In the Matter of
LONG ISLAND LIGHTING COMPANY
(Shoreham Nuclear Power
Station, Unit 1)

PREPARED DIRECT TESTIMONY OF
RICHARD B. HUBBARD AND GREGORY C. MINOR
ON BEHALF OF SUFFOLK COUNTY (SC)

SC CONTENTION 31 AND SOC CONTENTION 19(g)

ELECTRICAL SEPARATION

IEEE 384 LILCO
CABLE TRAY SEPARATION CRITERIA

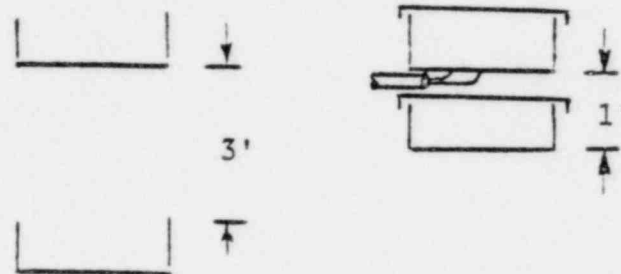
20. Second, LILCO and S&W have placed a strong reliance on alternate devices and techniques to make up for less than standard cable separation distances. For example, IEEE 384 and Reg. Guide 1.75 specify a separation distance of three feet between adjacent surfaces of stacked trays (e.g., from the bottom of the upper tray to the top of the lower tray should not be less than three feet). LILCO has set this distance at one foot from bottom-to-bottom, thus making the actual separation less than one foot - actually about eight to nine inches. The

distance is further reduced by allowing entry of exposed cables between the two separated trays.^{17/} (See following illustration.)

To overcome these extreme reductions of separation distances, LILCO has committed to add solid covers to the cable trays.^{18/} However, the trays are generally a ladder-type construction (i.e., open on the bottom except for metal cross rungs spaced several inches apart).^{19/} Thus, there is still an exposure

of one surface of the tray. The IEEE 384 standard allows less than three feet vertical separation but only for enclosed raceways (i.e. trays with solid-bottom, solid-top construction).
